Generic Environmental Impact Statement for License Renewal of Nuclear Plants

Supplement 1

**Regarding the
Calvert Cliffs Nuclear Power Plant**

Final Report

Figure 2-2. Calvert Cliffs Nuclear Power Plant Site Area, Land Uses and Growth Protection Areas

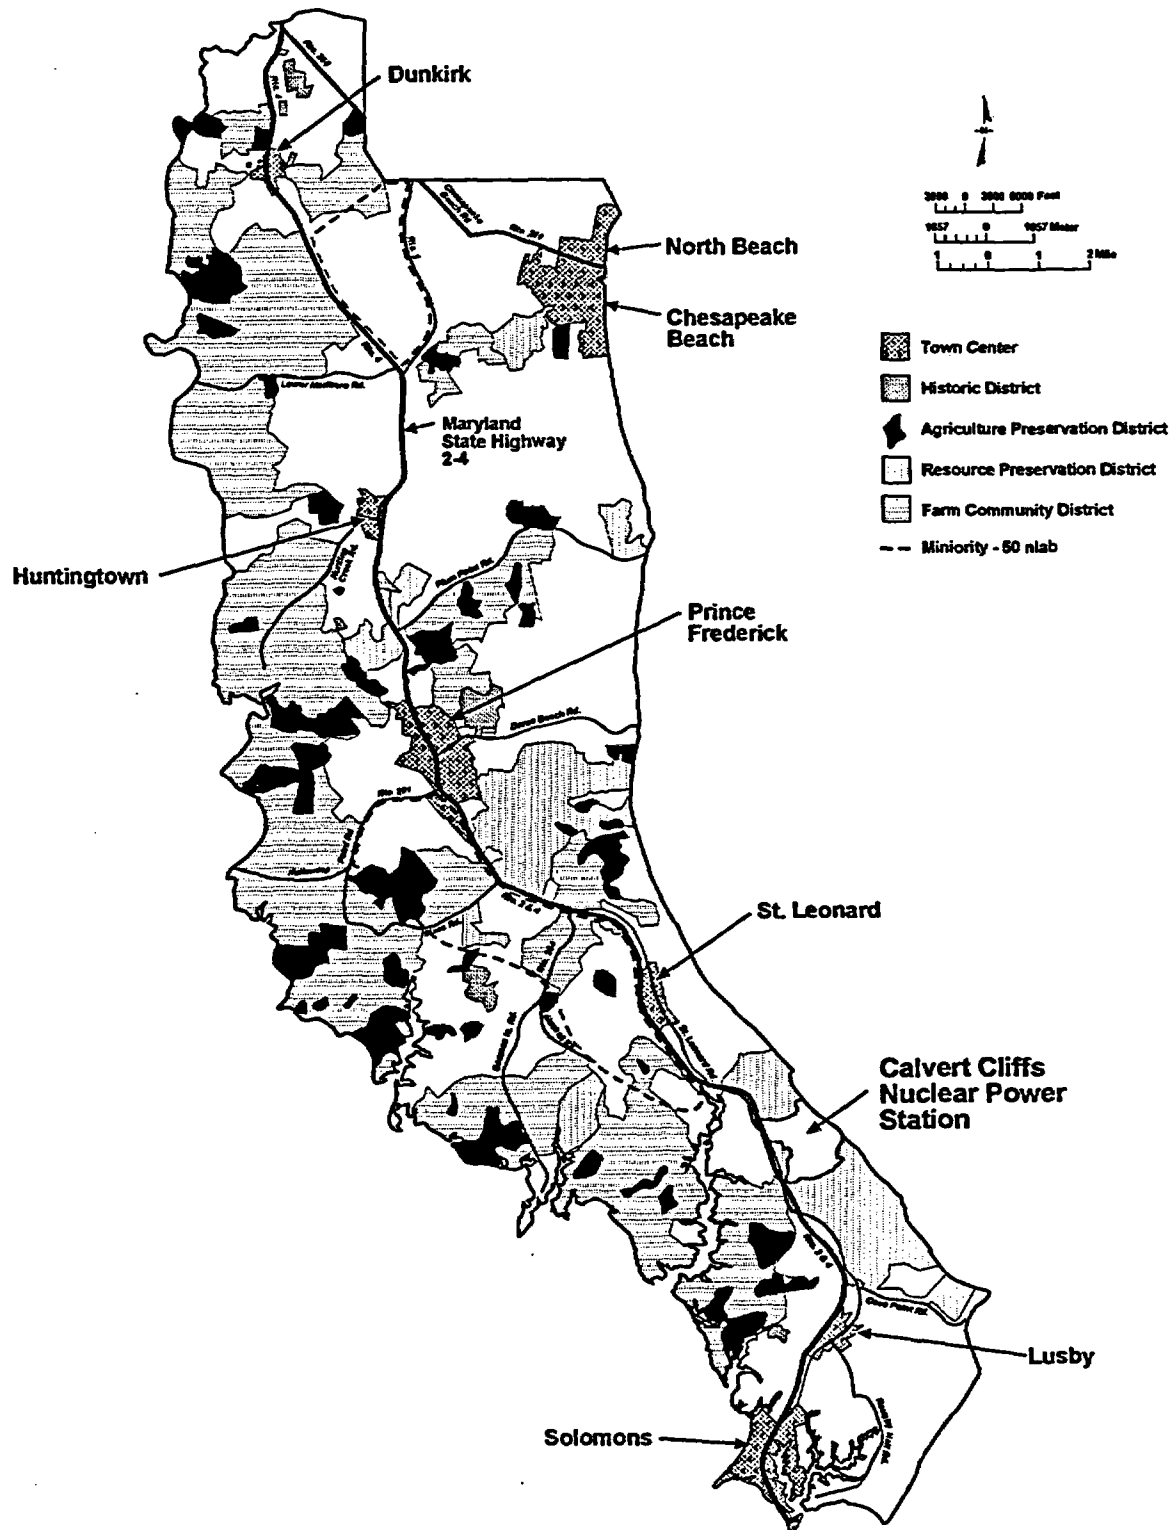
65.	2-31	7	Figures 2-2 and 2-3 show the CCNPP location, but do not show "general land use and planned land uses" as the text states.	Deleted reference to Fig 2.3, replacing Fig. 2.2

Figure 2-3. Calvert Cliffs Nuclear Power Plant Site Layout and Well Locations

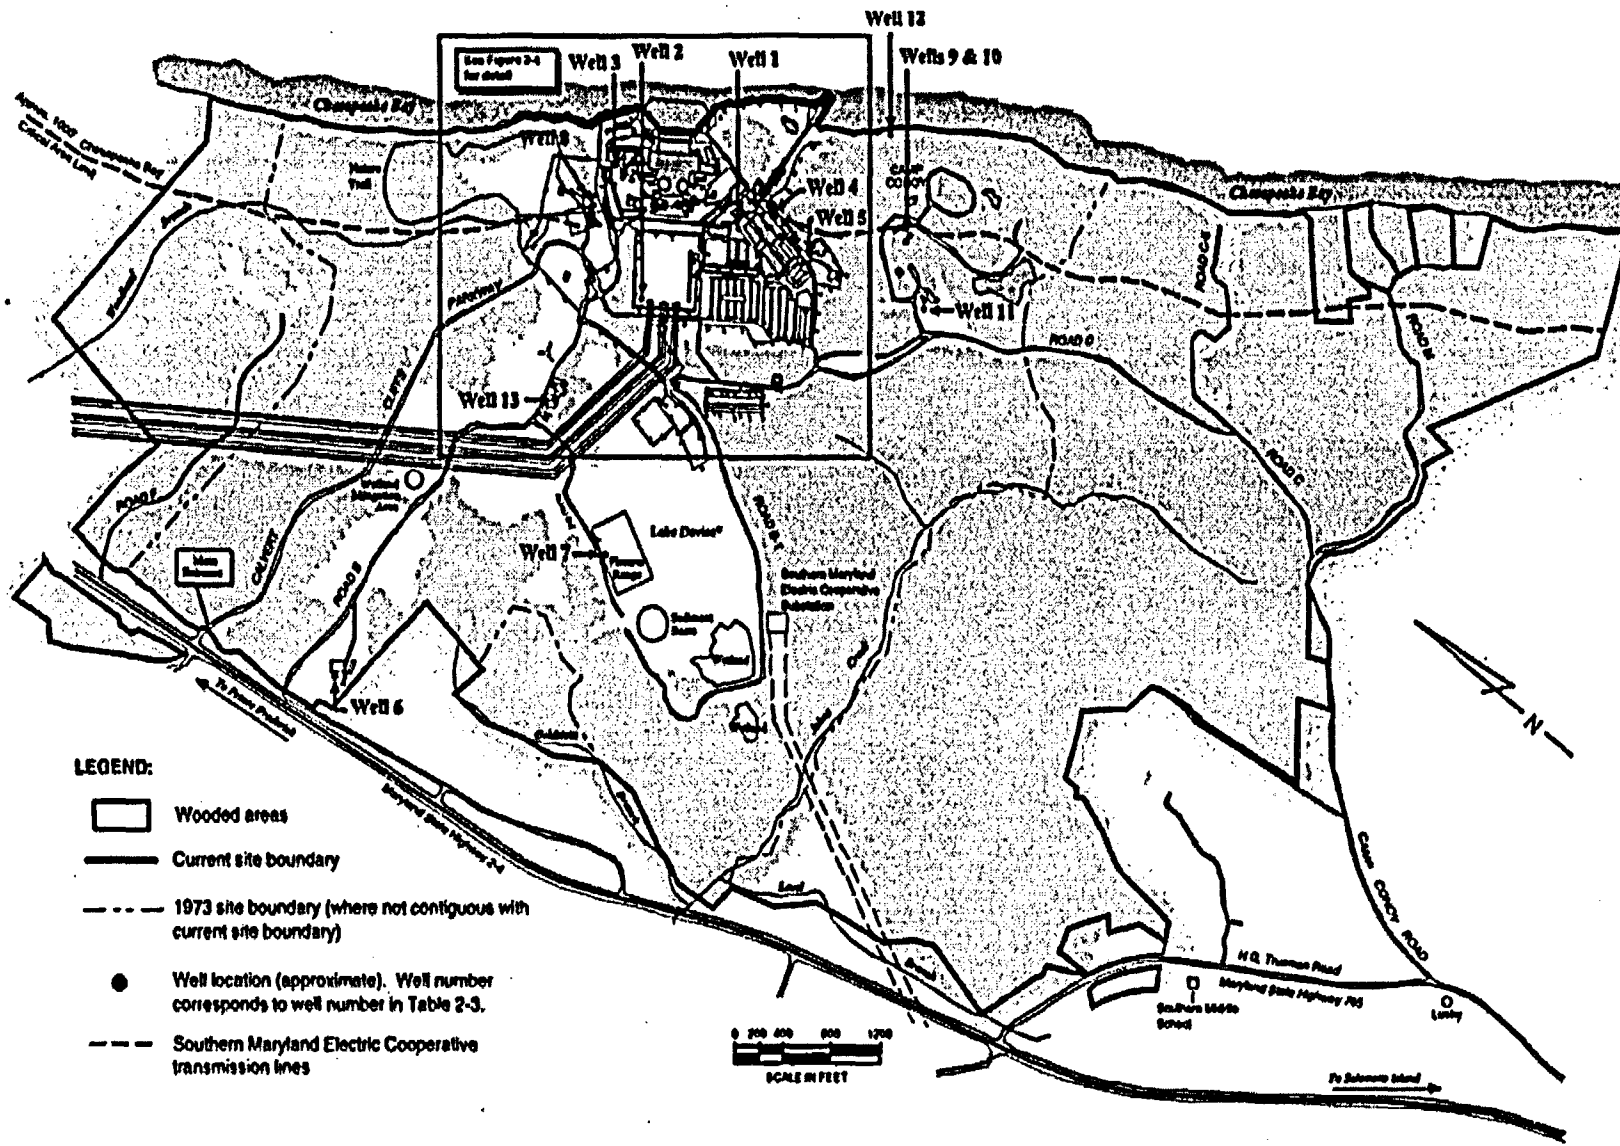
9.	2-5	Fig 2-3	The legend of the map should include 69-kV Southern Maryland Electric Cooperative (SMECO) transmission line, as this figure is called out (on page 2-16, line 46) in reference to this plant feature.	Clarified as suggested

Figure 2-7. Intake and Discharge Structures

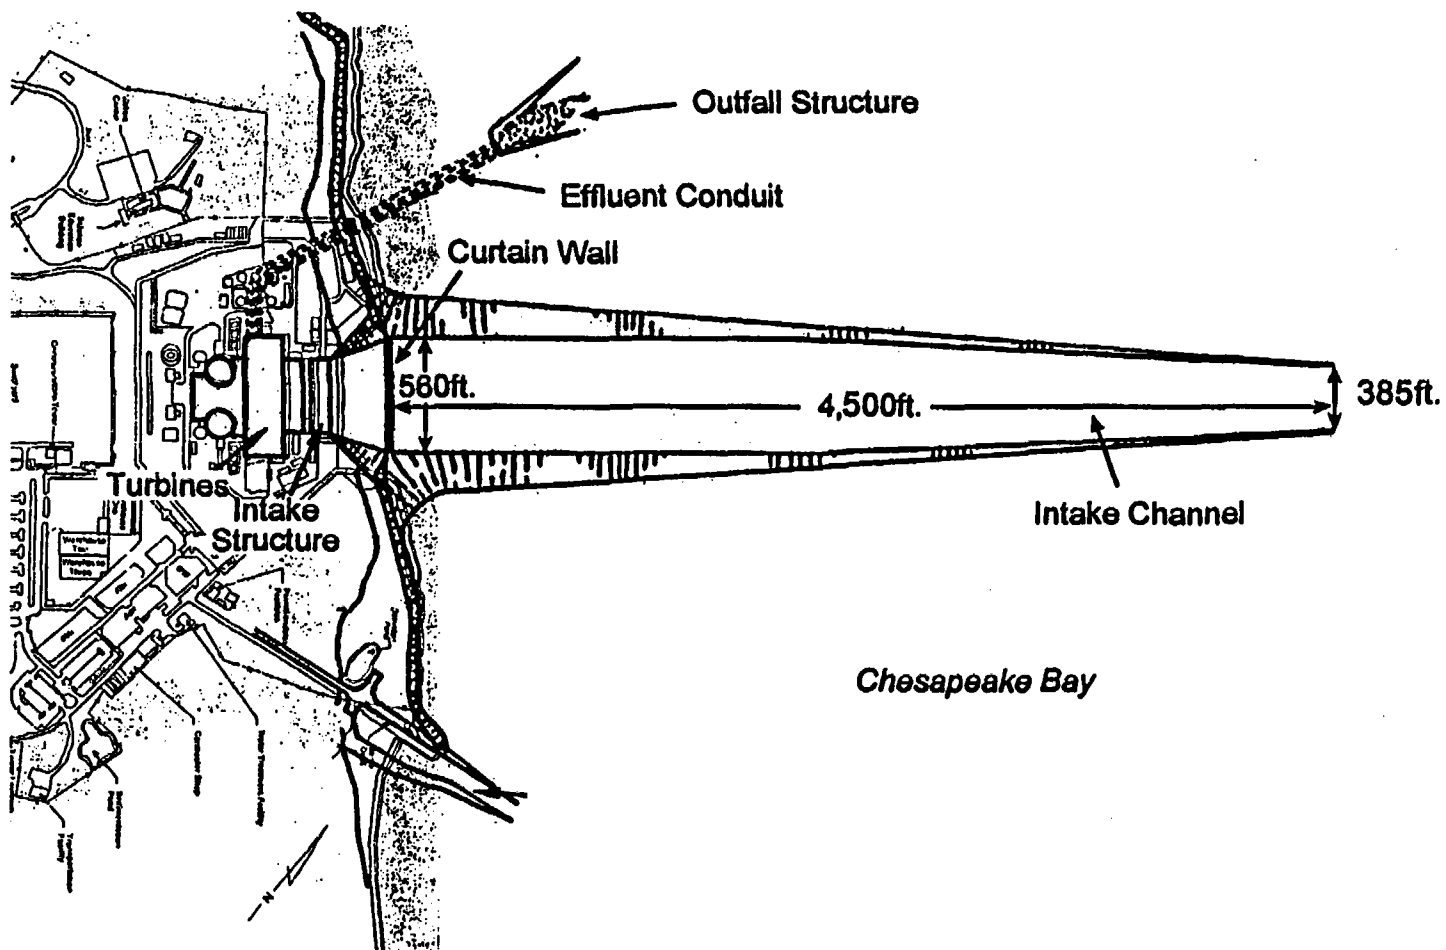
12.	2-10	27-29	A consistent source should be used for the dimensions of the intake and discharge channels. Calvert Cliffs' Updated Final Safety Analysis Report (UFSAR), Figure 1-3B, shows these dimensions to be approximately 4500 ft. and 850 ft, respectively. The intake channel length is taken from the baffle wall to the farthest point in the dredged channel, and the discharge channel length is taken from the shoreline to the end of the discharge conduit. (See comment for page 4-12, lines 9 and 15 and Figure 2-7.)	Dimensions changed per reference

14.	2-11	Fig. 2-7	The dimension of the intake channel should be shown to be "Approximately 4,500 ft." per UFSAR Figure 1-3B. (See comment for page 2-10, lines 27-29 and page 4-12, lines 9 and 15.)	Graphic dimension corrected

Figure 4-1. Geographic Distribution of Minority Populations (shown in shaded areas)
Within 80 km (50 mi) of the CCNPP

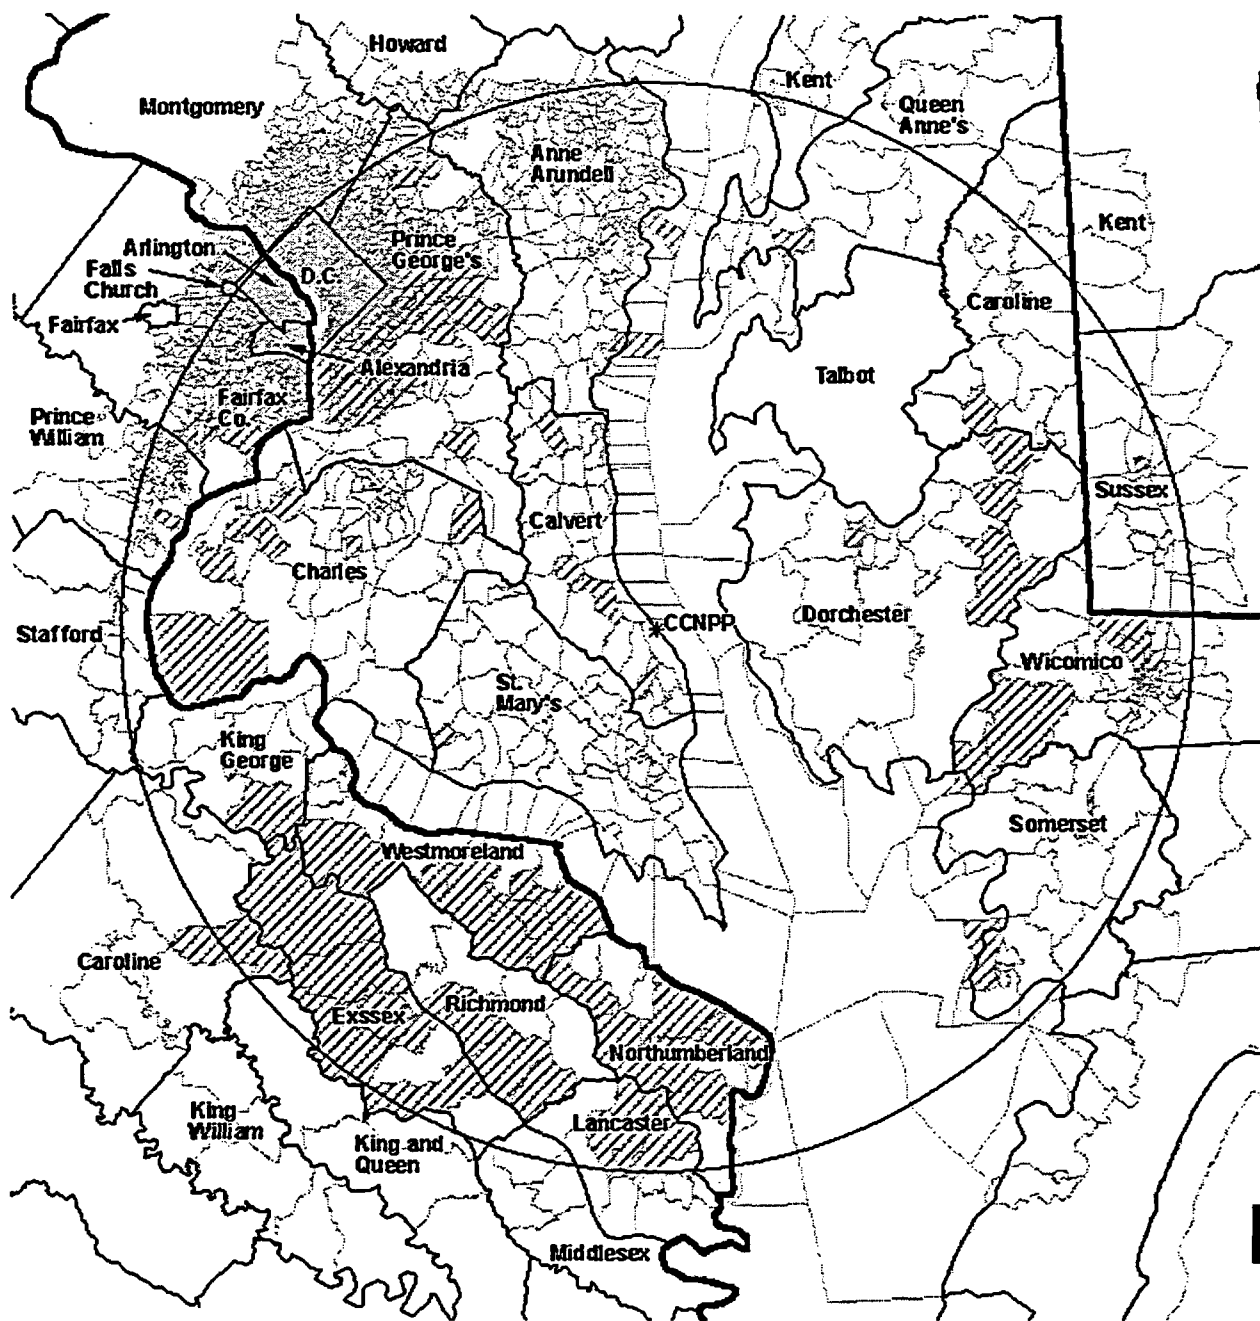
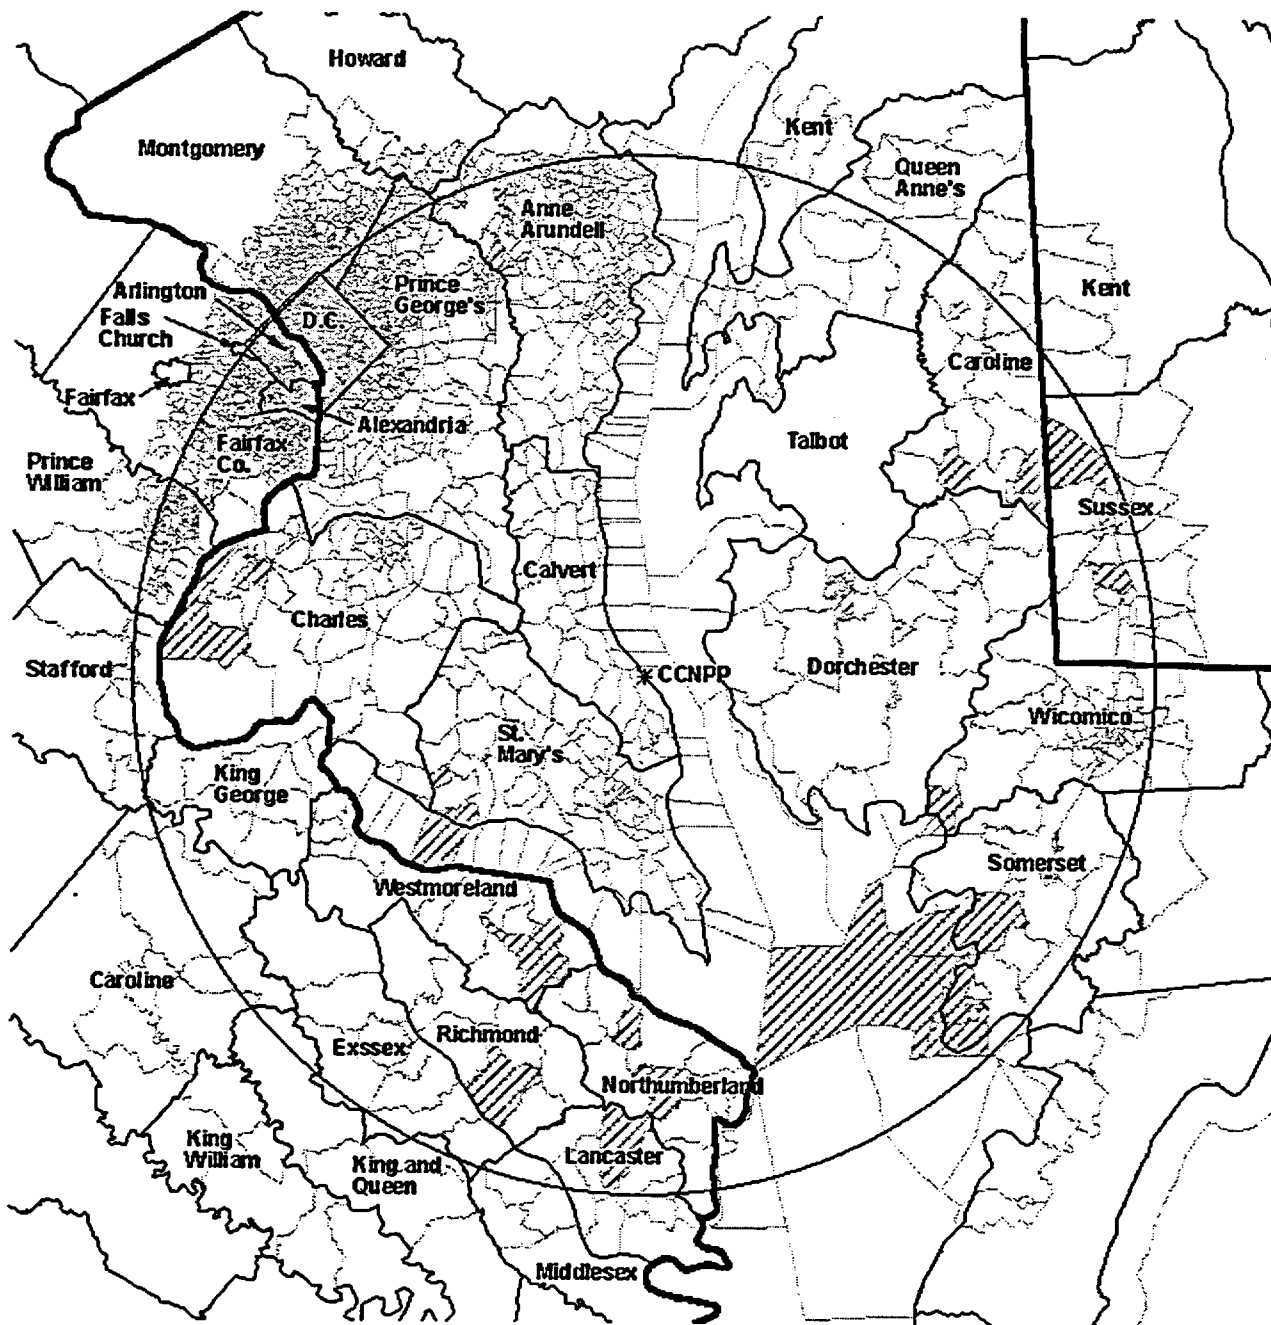
116.	4-24	35-36, and Figure 4-1	The figure appears to depict a 10-mile radius, rather than an 80 km (50-mile) radius as indicated. Also, a source reference for this map should be provided. The text on page 4-24, line 44-45 identifies specific communities; therefore, these communities should be identified on the figure.	Figures 4-1 and 4-2 replaced to be consistent with text

119.	4-25	Figure 4-1	The title for this figure is "Census Block Groups with Large Minority or Low-Income Populations." This appears to be inconsistent with page 4-24, line 36, which indicates that no Census block group showed a significant concentration of minority individuals. (This may be resolved by defining environmental justice terms, such as "minority", "low income", and "significant contribution.") In addition, to combine the two may be misleading. Two types of shading should be presented to represent each group (minority and low-income).	Figure and caption updated
